M1979155, Dotsero Cinder Pit, Inspection Report

MINERALS PROGRAM INSPECTION REPORT

MINE NAME: Dotsero Cinder Pit	MINE/PROSPECTING ID#: M-1979-155	MINERAL: Volcanic materials (ash, cinders)	COUNTY: Eagle
INSPECTION TYPE: Monitoring	WEATHER: Cloudy	INSP. DATE: November 28, 2022	INSP. TIME: 14:00
OPERATOR: Colorado Department of Transportation	OPERATOR REPRESENTATIVE: N/A	TYPE OF OPERATION: 110c - Construction Limited Impact

Figure 2: Northern-most parcel of approved permit boundary, overlaid on aerial image

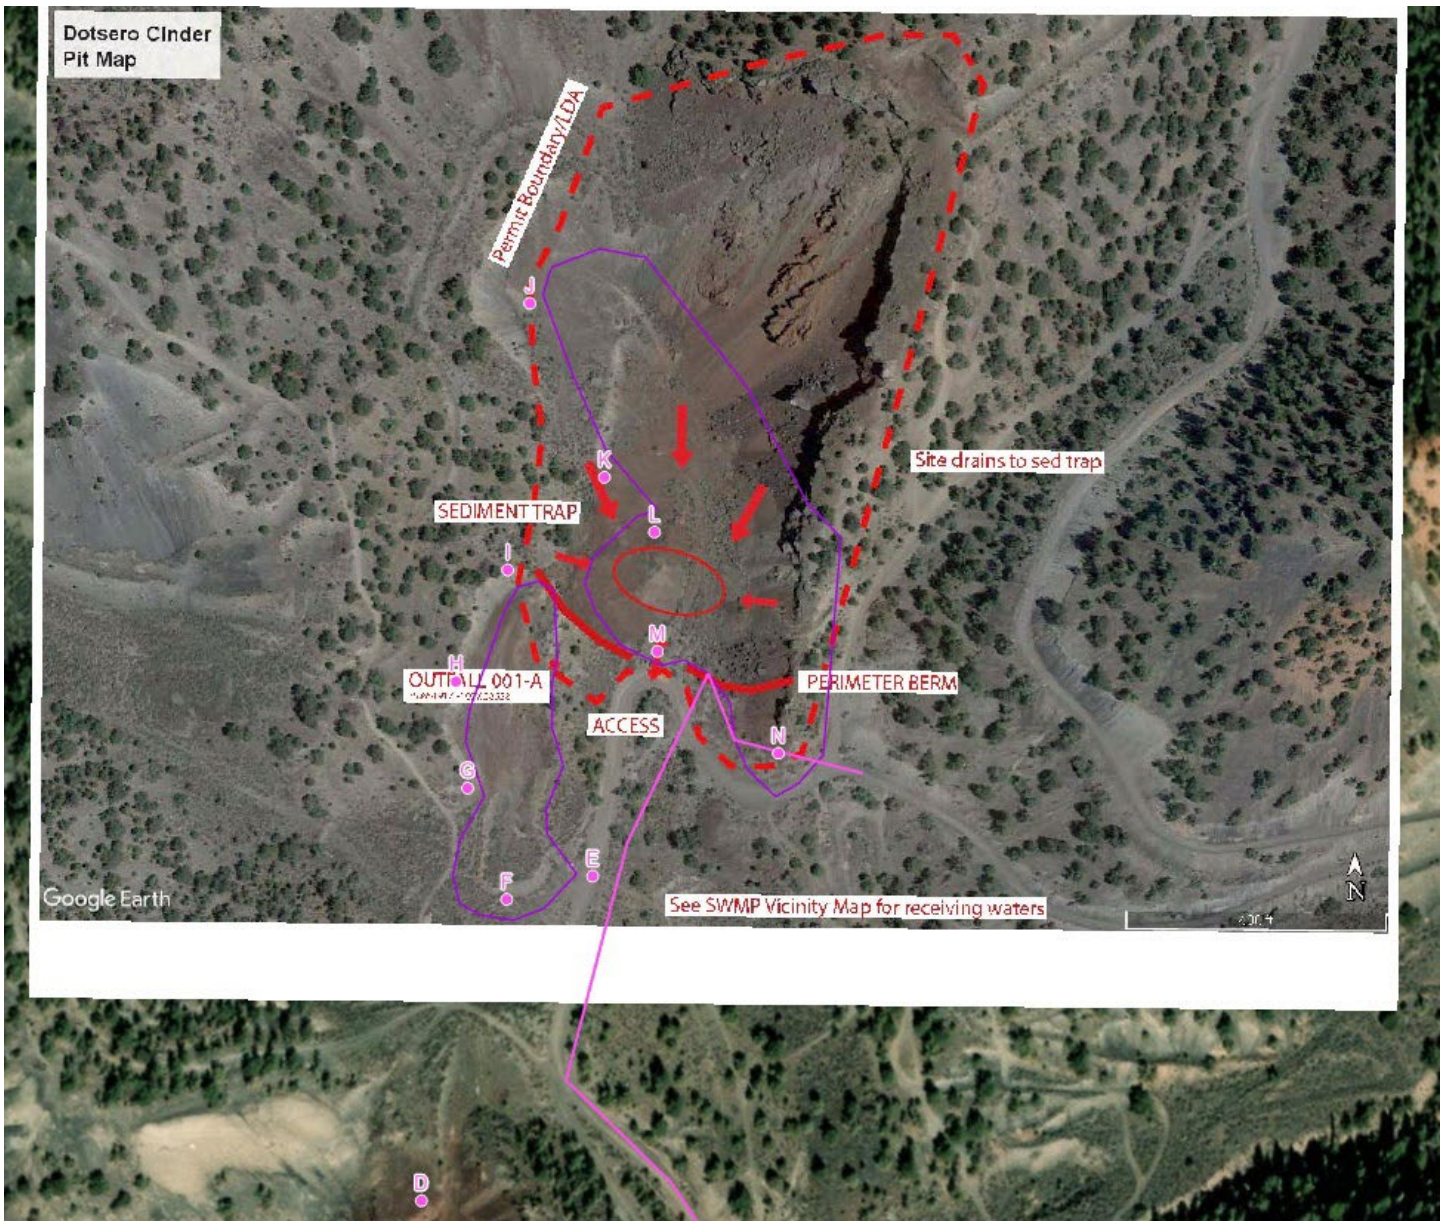
Figure 2 shows the northern-most parcel of the permit area (i.e. the "pit area"), overlaid on the aerial image, and Figure 3 shows the map submitted with annual reports from 2020-2023. It is clear that the red boundary line on the annual report map includes land that is outside of the approved boundary (purple polygon in Figure 2). Since the permit boundary cannot be revised with an Annual Report, there is either an error in the Annual Report map, or the operator has mined outside the permit boundary. In order to begin to resolve this issue, the operator should submit a Technical Revision to update the permit file with a Mining Plan Map and a Reclamation Plan Map that meet the requirements of Rules 6.2.1(2) and 6.3.5. Additionally, the Technical Revision must include updated mining and reclamation plans in accordance with Rules 6.3.3 and 6.3.4, which address the operational uses and reclamation procedures for each portion of the permit area.

CORRECTIVE ACTIONS: By the corrective action due date, the operator shall submit a Technical Revision, with the required \$216 revision fee, to update and clarify the current approved mining plan in accordance with Rule 6.3.3 to reflect existing and proposed activities. Additionally, the revision must include an updated mining plan map that meets the requirements of Rules 6.2.1(2) and 6.3.5(2). This map must unambiguously establish the location of the approved permit boundary. This will help to resolve any confusion caused by differences between the map submitted with the original application, a map submitted in response to a 2012 inspection (but never added to the permit through the appropriate revision), and maps submitted with recent annual reports.
